Memo

Re: Consultation on an Application

Planning Application Ref: PL/26/0383

Proposal: Application for Approval of Details Reserved by Condition 4 (Hard and Soft Landscaping) of application PL/25/0808

TPP - PL/25/0808

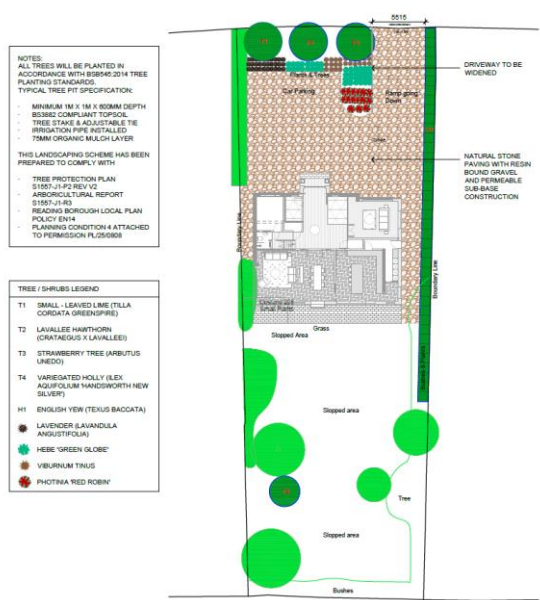
The indicative landscaping is shown below in the approved TPP referred to in Condition 4:

Four trees are expected to be planted on the frontage, as shown in the approved TPP. I note only 3no. trees have been proposed on the frontage with 'PHOTINIA 'RED ROBIN' (shrub) have replaced one of the expected trees, set further back from the frontage, as shown in the TPP (see below for said expected tree).

Newly Proposed Landscape Plan

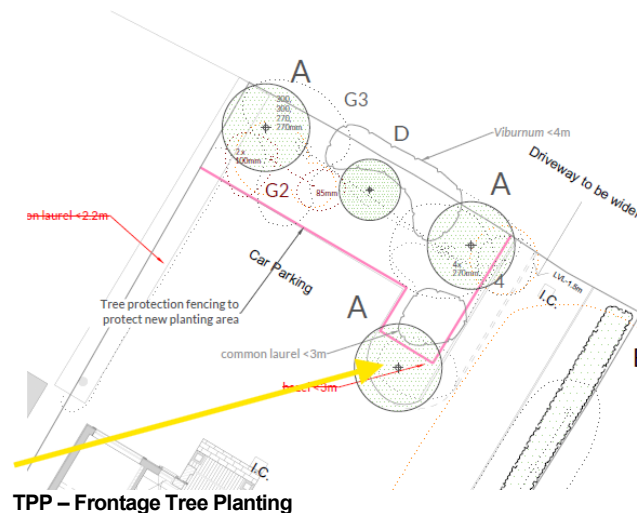
I have attached and extract from the AIA which demonstrated the species presented to us at the application stage. Said tree was a small-leaved Lime tree (*Tilia cordata* 'Greenspire'). A *Photinia* 'Red Robin' shrub, is not an appropriate replacement species for a small-leaved Lime, as these Lime trees have much greater ultimate size potential than that proposed. Therefore, as this planting was agreed as indicated in the TPP, a tree species with the same (or similar) growth/size potential as a small-leaved Lime is expected.

I also note T3 of the Landscape Plan is also not a species with the same size potential as that originally proposed at the application stage. This was intended to be another small-leaved Lime tree. We expect species of a the same or similar size potential of that originally demonstrated to us, which a 'STRAWBERRY TREE (*ARBUTUS UNEDO*)' does not.

T2 & T4 of the Landscape Plan are fine in terms of species as we agreed to these at application stage. T2 being the Lavallée Hawthorn, mentioned above. So an alternative, larger species is required for T3 plus an additional tree in the place proposed for *Photina*.

The Landscape Plan also refers to hedging, 'H1' along the southern boundary. H1 (*Taxus baccata* - Yew) is labelled on the Landscape Plan which is clear and positive. The Landscape Scheme document states species, size and spacing so I can confirm I am happy with this.

In addition, in terms of stock size of new trees, only the girths have been stated for T1-T3 and only the height for T4. For clarity, we require both the girth and height at the time of planting to be stated.

The extent of the retained vegetation is difficult to appreciate as the TPP, Demolition Plan and Landscape Plan perimeters of vegetation don't appear to be completely reflective of one another. The Landscape Plan should be clear, with appropriate labelling, of retained vegetation.

I note that the means of enclosure aren't fully demonstrated. The Landscape Scheme, mentions means of enclosure as '*Boundary fencing will include mammal gaps measuring 100mm x 100mm at ground level to allow movement of hedgehogs and other small mammals between gardens. This supports biodiversity objectives.*' I do not note the material of the boundary fencing stated so it is unclear whether the existing boundary treatment will remain or if there is newly proposed. I acknowledge some planting will act as boundary treatment i.e. southern boundary being H1 Yew hedging, but is fencing proposed adjacent to it? I do not note said mammal gap locations marked on the Landscape Plan. This could be resolved by stating the boundary treatment will remain as

The hard landscaping in the Landscape Scheme details the use of different materials. The Landscape Plan doesn't have a key which demonstrates which material is proposed in what location and extent of which; so it is difficult to appreciate the extent of the paving vs gravel. The Landscape Scheme states '*NATURAL STONE PAVING WITH RESIN BOUND GRAVEL AND PERMEABLE SUB-BASE CONSTRUCTION*' – paving and gravel are different materials so I am unclear on which is proposed, and if both, the extent of each.

We indicated the need for diversity in planting at the application stage hence requested changes to the 3no. Lime trees alongside the agreed 1no. Lavallée Hawthorn; but we expect species of a similar size potential as that originally proposed. For clarity, I am happy for 1no. of the replanted trees to be a small-leaved Lime alongside the agreed 1no. Lavallée Hawthorn, but the remaining 2no. trees should be of a different species yet similar size potential as the small-leaved Limes originally proposed.

To conclude, currently there is insufficient information to discharge to condition. The tree planting on the frontage is of a lesser number of trees than agreed at application stage. The trees should be of a similar size potential as that demonstrated (small-leaved Limes), but with a diverse range of species included. The maintenance programme needs to be further detailed – I have provided some examples above. The differences in hard surfaced materials need to be clear, using different colours with keys, or being clearly labelled. Tree pit sectional diagrams also need to be provided, with reference to the latest practices and taking this into account with the their stock size and size of their root systems to calculate an appropriate tree pit size. Both the height and girth at time of planting needs to be stated for the trees.
